SUBJECT: Forwards revised FSAR Section 7.3 re control sys & automatic depressurization sys. Revs will be incorporated in next FSAR amend.

SUSQUEHANNA STEAM ELECTRIC STATION
FSAR SECTION 7.3
ER 100508 FILE 841-1
PLA-1819

Docket No. 50-388

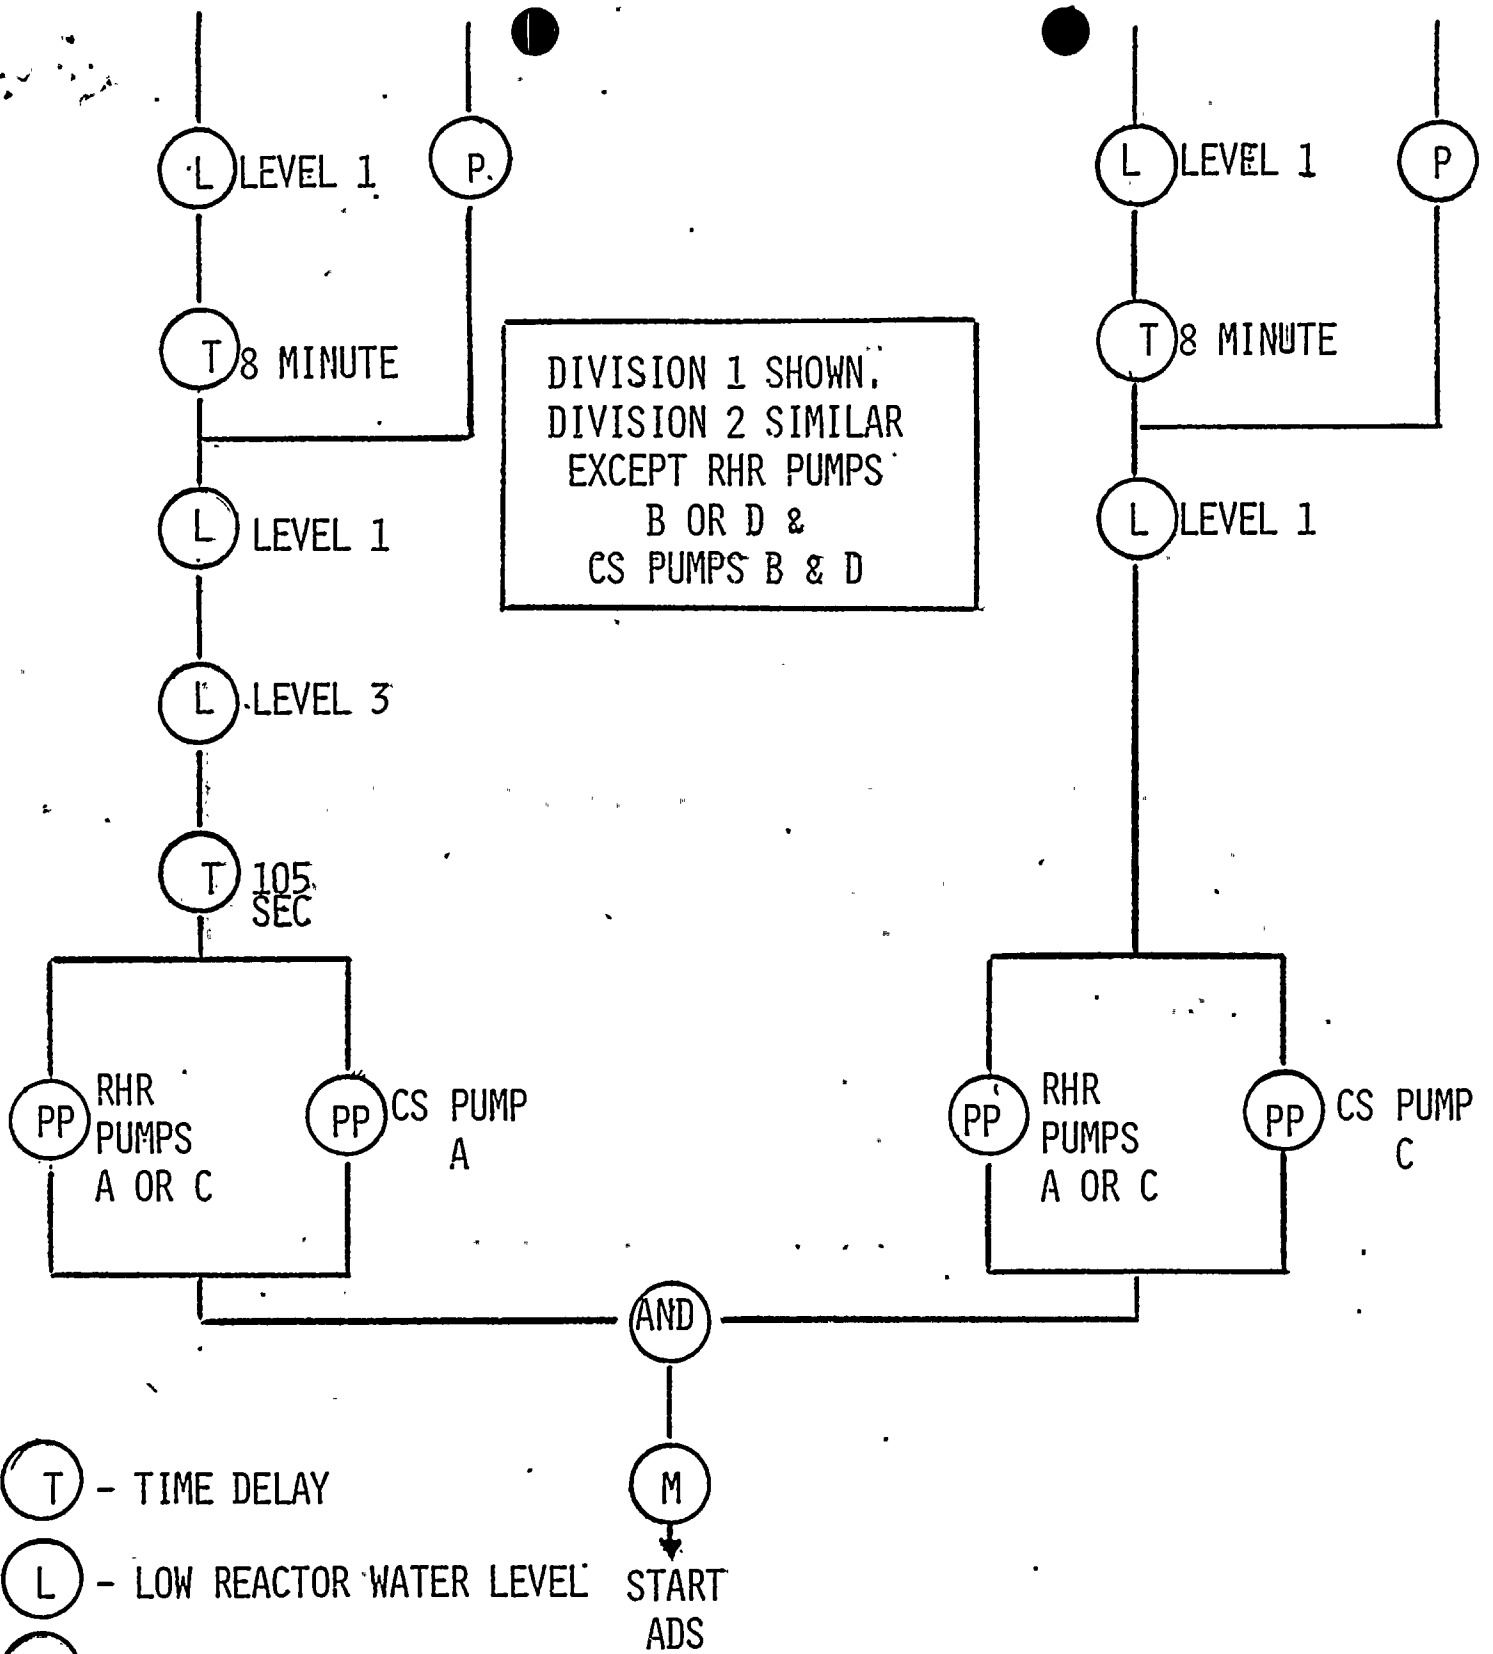
- 7.3.1.1a.1.4.3 - This section has been revised to show the NRC approved modifications to the Automatic Depressurization System for Unit 2.
- 7.3.1.1b.8.1.6 - The ESW pump discharge header temperature instrumentation has been deleted from this list since it has been upgraded because of Regulatory Guide 1.97 requirements.
- 7.3.1.1b.8.3.5 - This section has been added to describe the safety-related portion of the Unit 2 containment instrument gas system.
- Fig. 7.3-5, Sht. 3 - This figure has been added to show the initiation logic for the Unit 2 ADS.
